**ADDENDUM NO. 1 TO PROJECT NO. 45425
CONSTRUCTION WORK & ELECTRIC WORK
PROVIDE MOV & POV PARKING LOTS
CAMP SMITH TRAINING SITE
11 BEAR MOUNTAIN BRIDGE ROAD
CORTLANDT MANOR, NY 10567**

August 17, 2016

SHEET TITLE
MODIFIED GENERAL INFORMATION PLAN,
REFERENCE L-001

C1 PHASING PLAN
1" = 100'

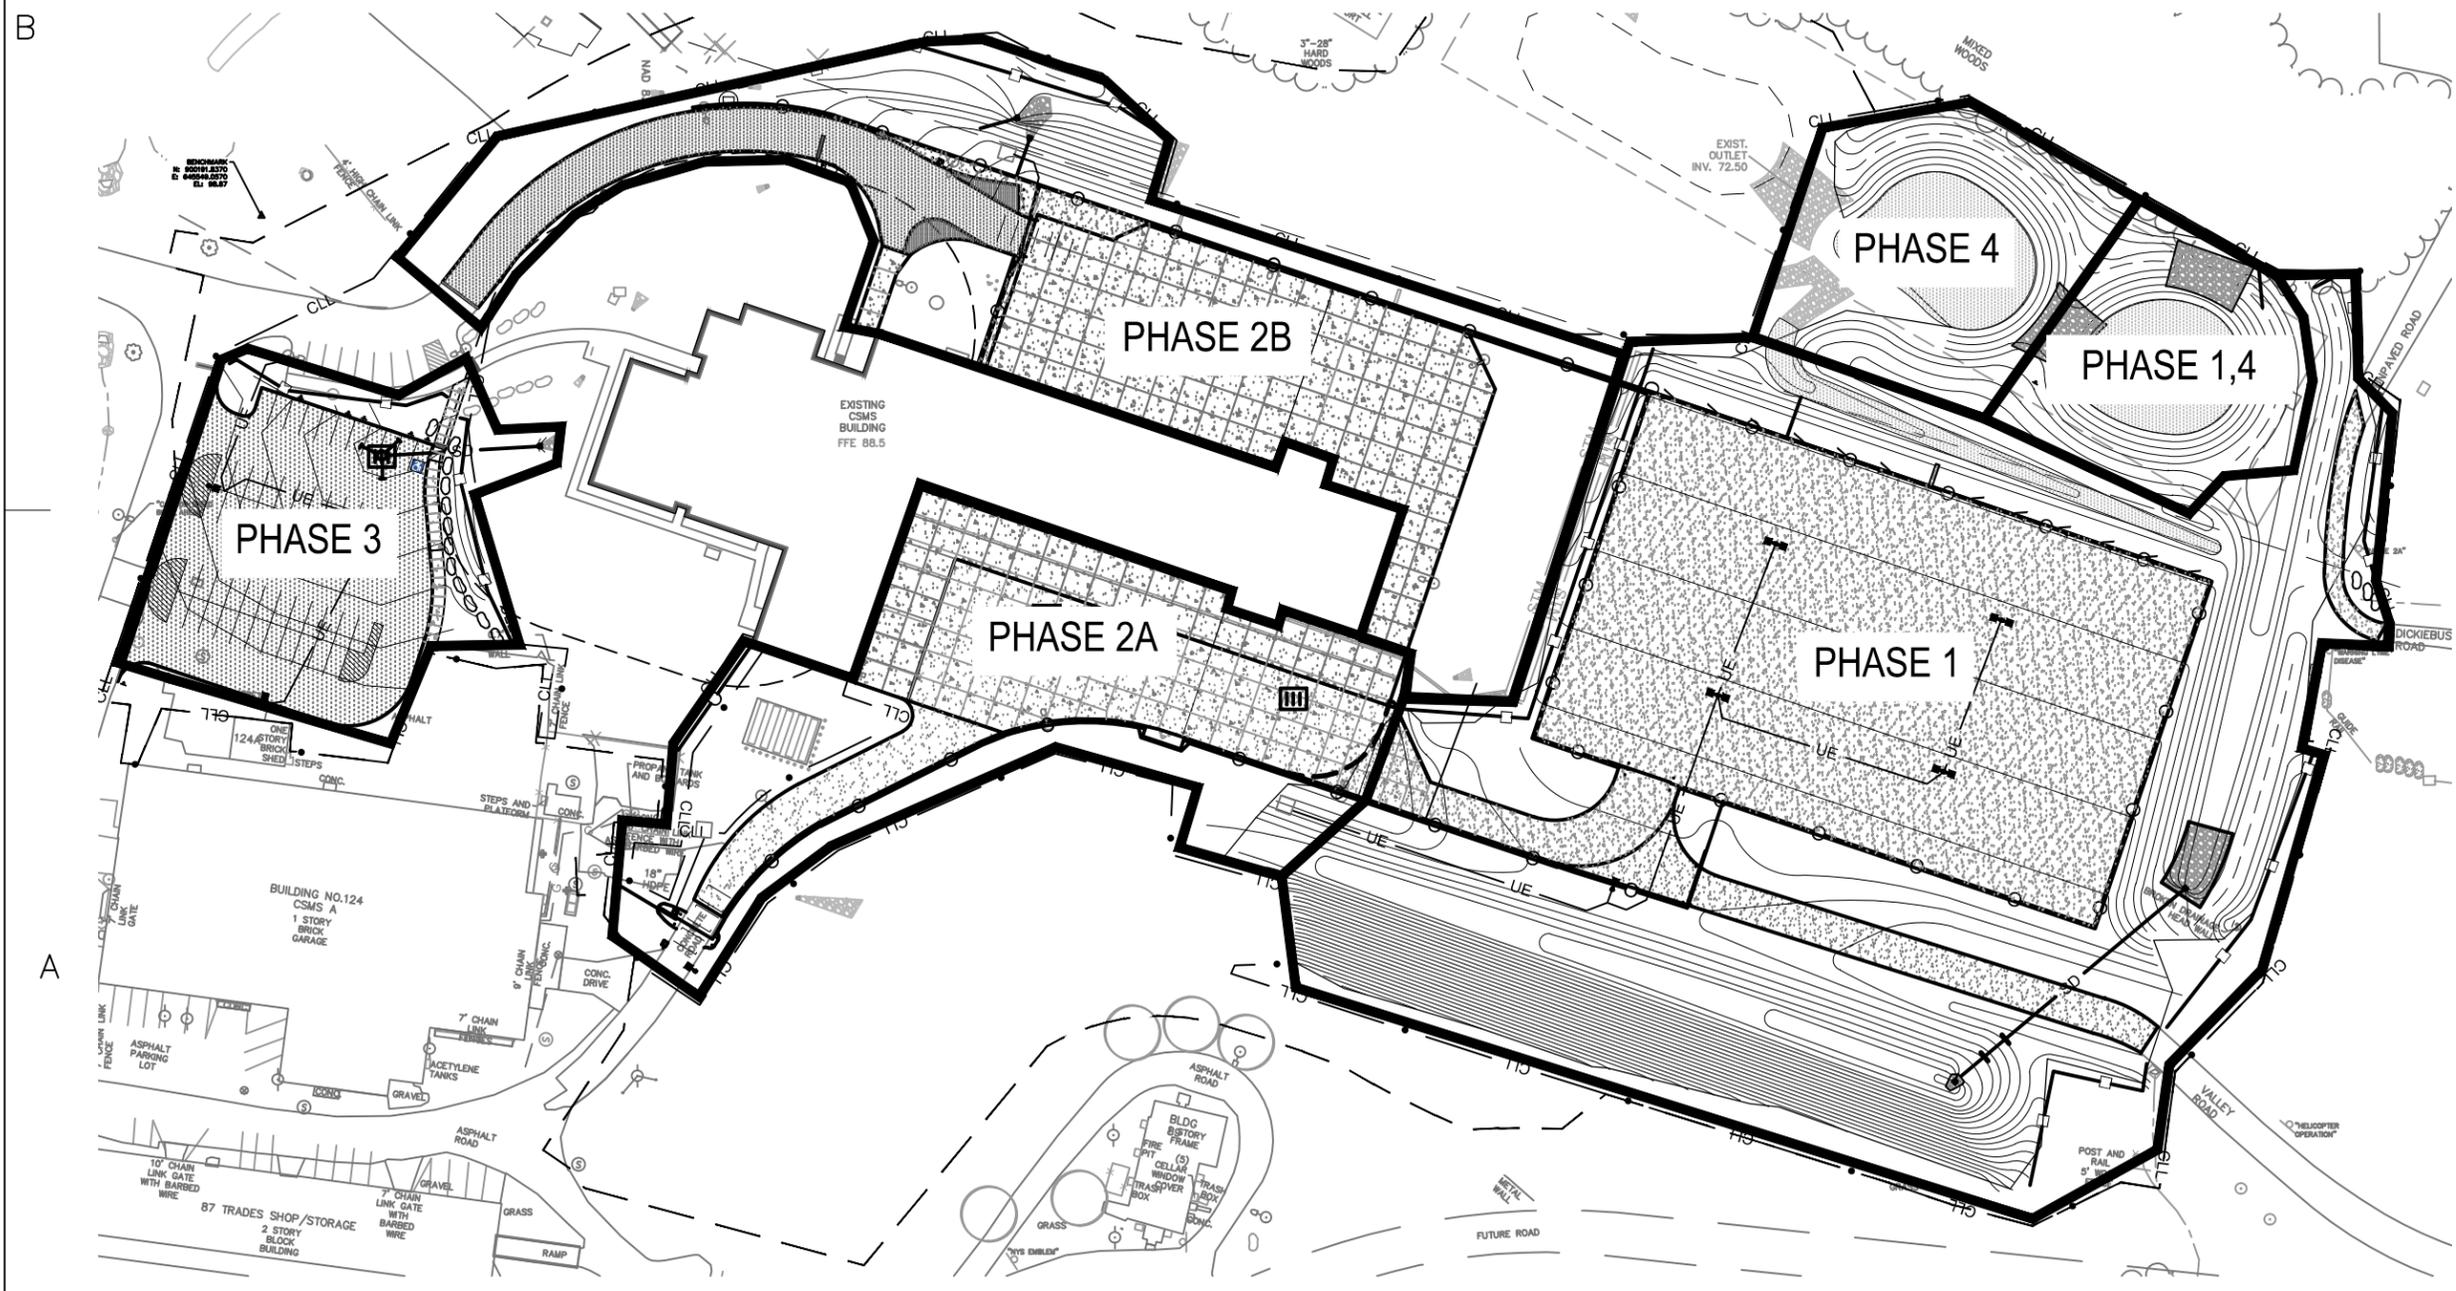
1. Drawing No. L-001
 - a. Detail C1; Add detail with JD-L1 Addendum Drawing dated 17 August 2016 to show proposed phasing.
2. Drawing No. L-103
 - a. Storm Inlet located at south parking lot shall have an invert elevation of 88.70' at storm pipe connection.

PHASING GUIDELINE / ALLOWABLE CONSTRUCTION START DATES AND NOTES:

- PHASE 1 (FALL 2016): CONSTRUCT NORTHERN PORTION OF THE SITE INCLUDING MOV PARKING LOT AND TOPSOIL PILE OVER PROPOSED INFILTRATION BASIN
- PHASE 2A (JUNE 1, 2017): CONSTRUCT EAST SIDE OF CSMS BUILDING (ONE SIDE OF CSMS BUILDING MUST HAVE ACCESS DURING CONSTRUCTION)
- PHASE 2B (JUNE 1, 2017): CONSTRUCT WEST SIDE OF CSMS BUILDING (ONE SIDE OF CSMS BUILDING MUST HAVE ACCESS DURING CONSTRUCTION)
- PHASE 3 (OCTOBER 10, 2017): CONSTRUCT SOUTH PORTION OF THE SITE INCLUDING POV PARKING LOT
- PHASE 4 (NOVEMBER 1, 2017): FINISH CONSTRUCTION OF FOREBAY AND INFILTRATION BASIN

NOTE:
THESE PHASING GUIDELINES PERTAIN TO BASE BID AND BID ALTERNATE SCOPE AS WELL IF AWARDED
